## Currie Street Pty Ltd C/Masterplan

25-storey mixed use building comprising commercial at ground, office and hotel accommodation at upper levels

### 62-68 Currie Street, Adelaide

020/A019/19

1 DA420 - ENTRY HOOD  
DA400 1:25

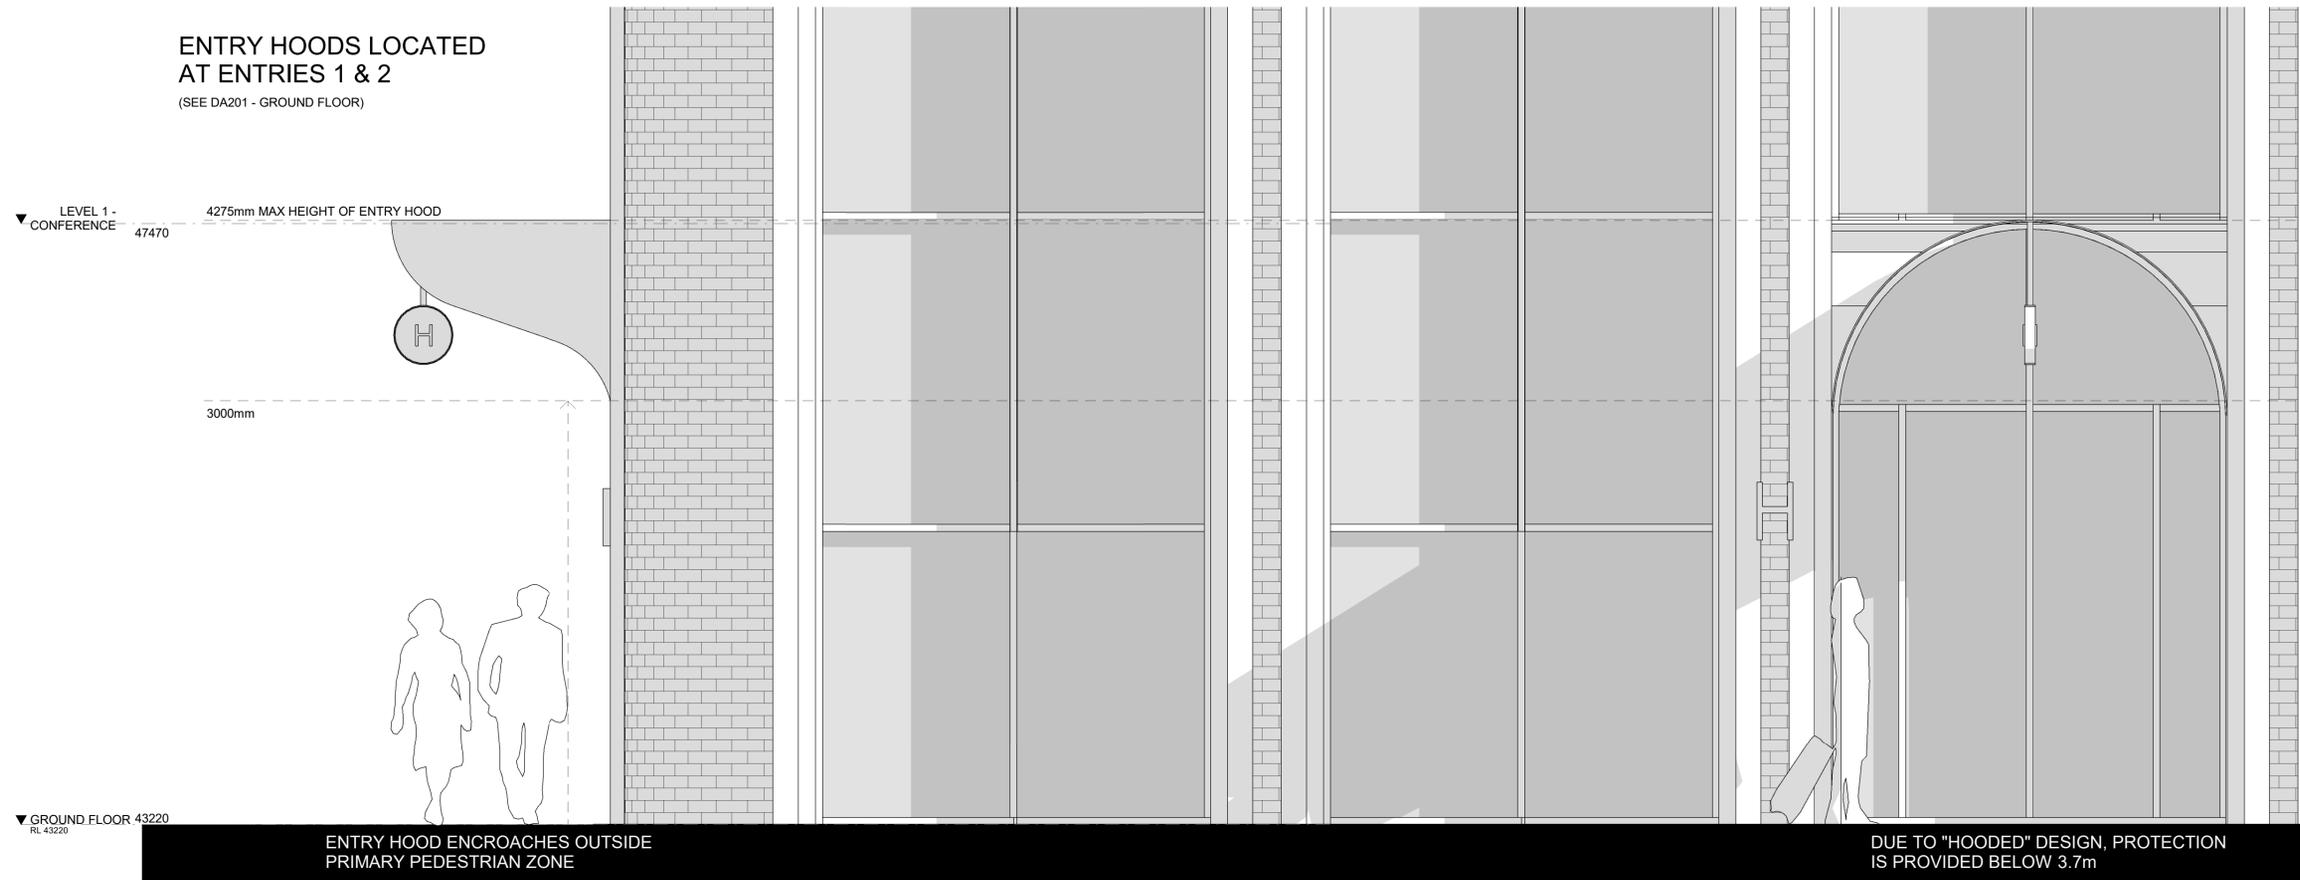
**Response:** *While a detailed explanation of the canopy design and consideration of the encroachment policy had been provided with the application demonstrated compliance with the "Intent" of the policy, the canopies have been redesigned to fully comply with the numerical guidelines. Please refer to the attached Entry Hood Drawings.*

**ENTRY HOODS LOCATED  
AT ENTRIES 1 & 2**  
(SEE DA201 - GROUND FLOOR)
